Reference: Hanford Waste Vitrification Plant
DOE Contract DE-AC06-86RL10838
Fluor Contract 8457

Transmittal No.: WDOE-958

FLUOR DANIEL US DEPARTMENT OF ENERGY HANFORD WASTE VITRIFICATION PLANT DESIGN CHANGE NOTICE	DCN - 0189	REV 0	PAGE 1 OF 5
	DCN TITLE	DATE INITIATED 5/11/94	
	HWMA WATER SUPPLY	PACKAGE NO. A160

THIS DCN PROVIDES A NEW TEE AND VALVE IN PIPELINE FWX-6"-056. IT ALSO RELOCATES AND REVISES THE VALVE NUMBER OF EXISTING VALVE MV-FWX-056 TO MV-FWX-056-1. THE PURPOSE OF THESE CHANGES IS TO PROVIDE A CONNECTION POINT FOR A FUTURE WATER SUPPLY LINE TO THE SAFETY SHOWER LOCATED IN THE HAZARDOUS WASTE MATERIALS ACCUMULATION (HWMA) FACILITY.

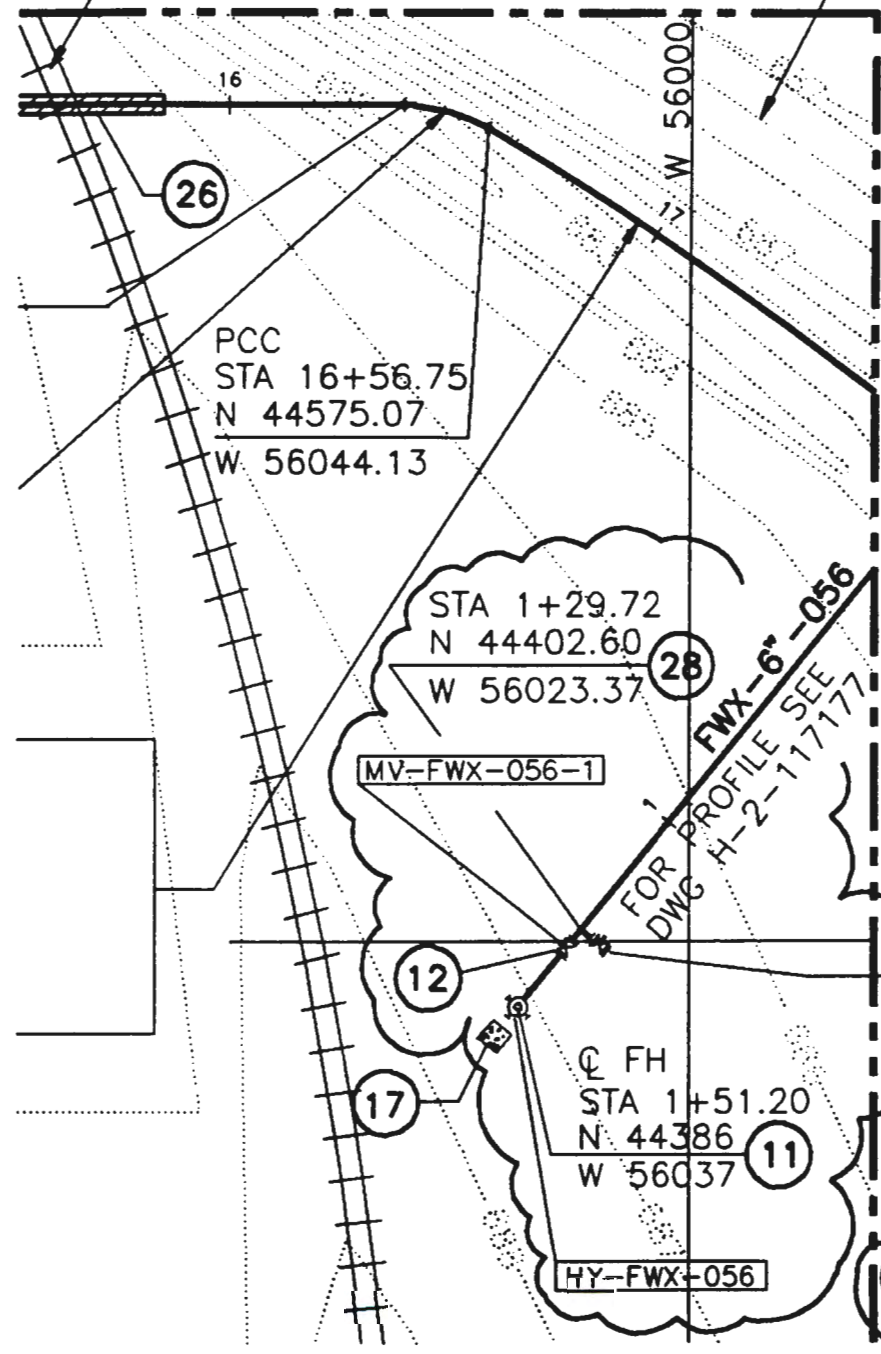
DOCUMENT NUMBER	SHT/PAGE	REV NO	DOCUMENT NAME	INCLD Y/N	DESCRIPTION OF CHANGE
H-2-117152	1	4	CIVIL, UNDERGROUND UTILITY PLAN	Y	PROVIDE NEW TEE AND VALVE, MV-FWX-056-2, IN PIPELINE FWX-6"-056 (ZONE F4) AND RELOCATE VALVE MV-FWX-056 FROM DWG H-2-117153 AND RENUMBER TO MV-FWX-056-1
H-2-117153	1	5	CIVIL, UNDERGROUND UTILITY PLAN	Y	RELOCATE VALVE MV-FWX-056 (ZONE F8) TO DWG H-2-117152
H-2-117177	1	3	CIVIL, SWX, FWX, AND DRX PIPE PROFILES	Y	PROVIDE NEW TEE AND RELOCATED PIV VALVE IN PROFILE FWX-6"-056

PER DCN 0189

MV-FWX-056-2
BLD FLG W/
2" BALL VALVE

28 - 6" X 6" X 6" TEE

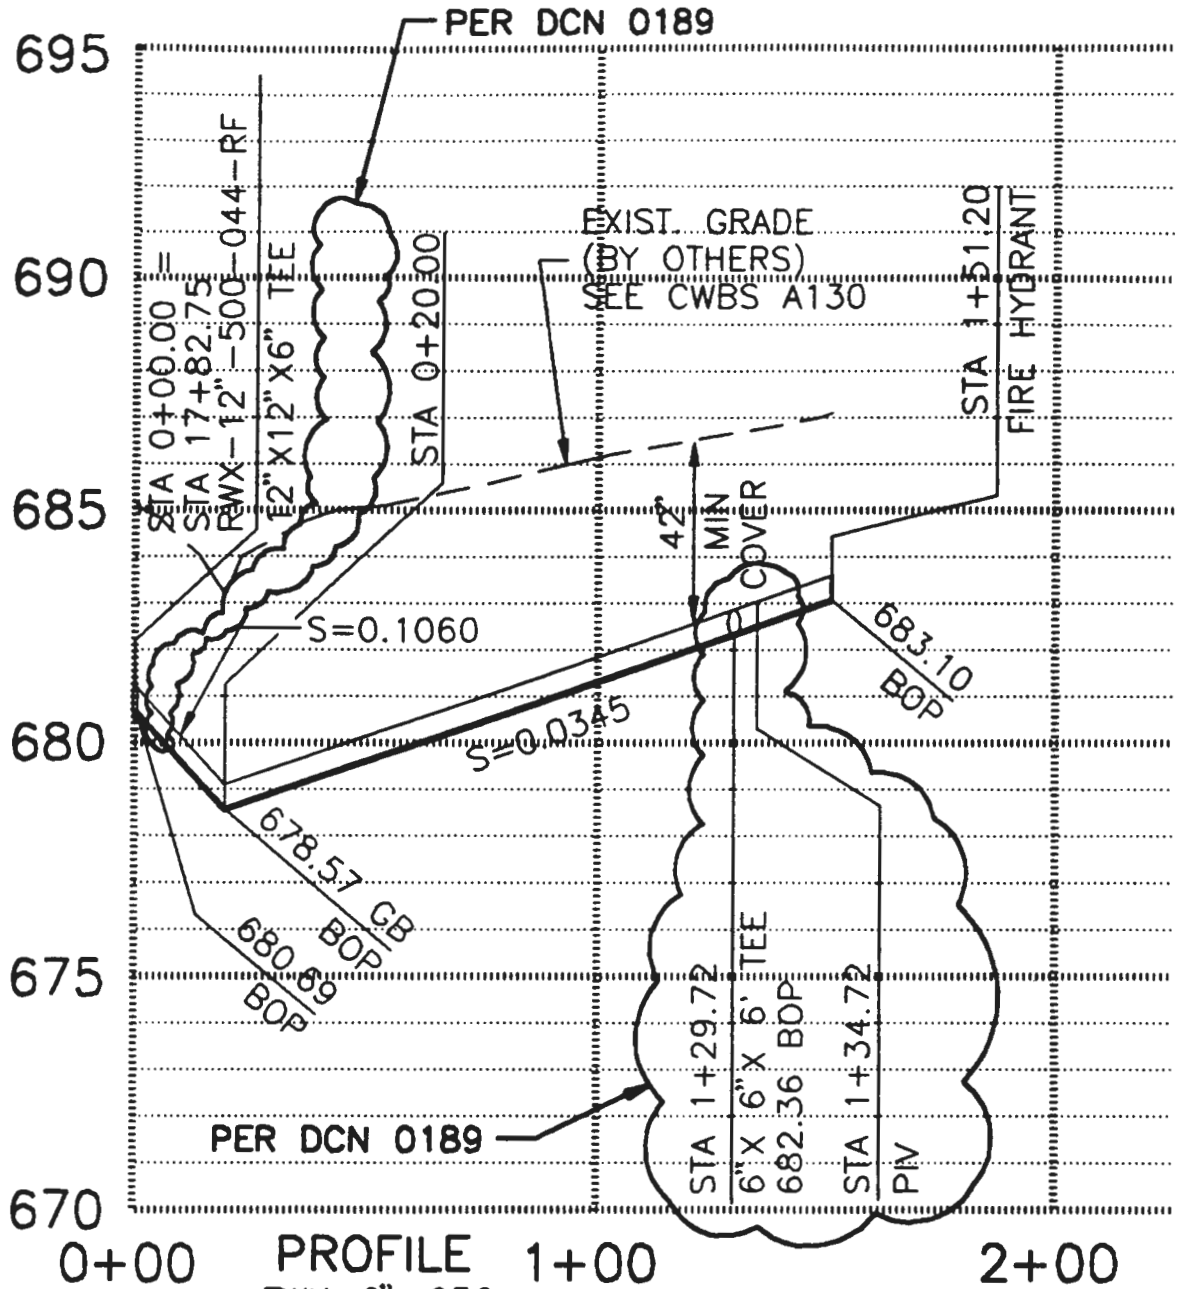
0+00 PROFILE 1+00 2+00
 FWX-6"-056
 HORIZ. 1"=40'
 VERT. 1"=4'
